Pantyffynnon, River Loughor Weir Removal

FRAP Reference: DFR/S/2021/0237

Figure 6. Visual impression of before and after works

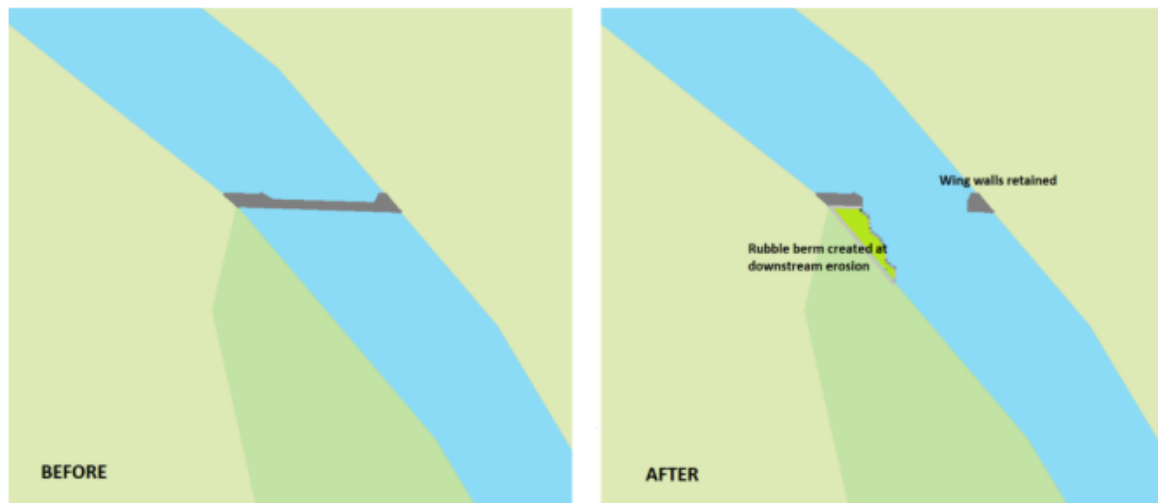
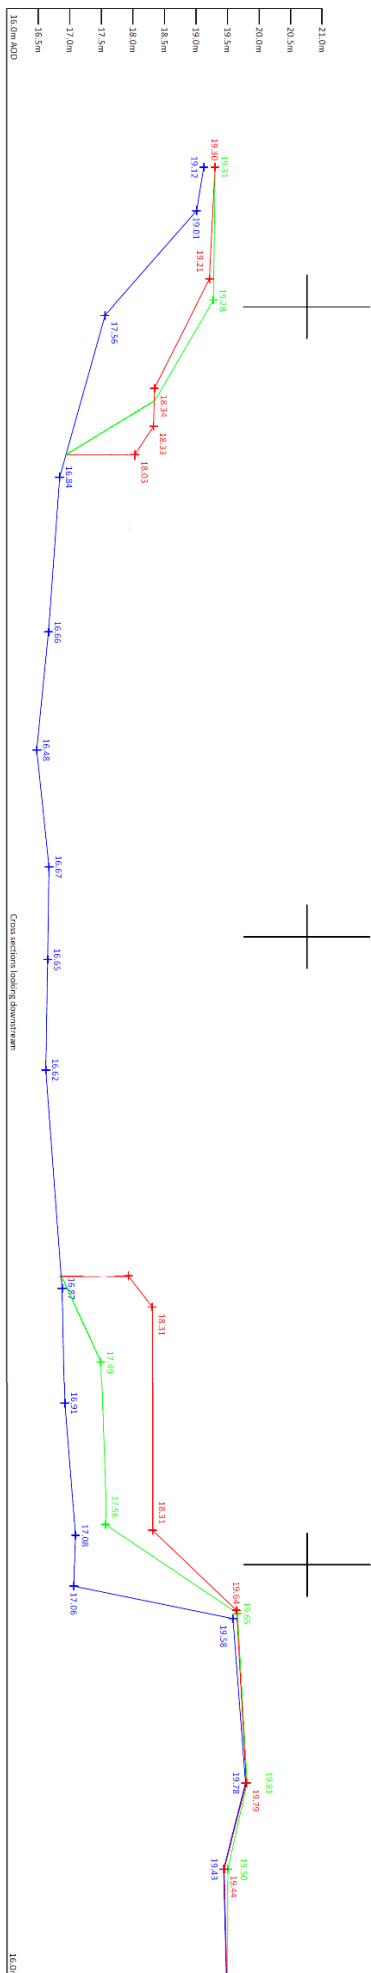
Response to comments in previous application:

We can confirm that any remaining infrastructure (the wing walls) will not impound the watercourse, including during high flows:

- The retained wing walls will not raise the upstream water level outside the normal (non-flood conditions) wetted perimeter of the stream?
- The remaining structure will not modify the natural flow regime due to the small length retained compared to the over-widened channel width.
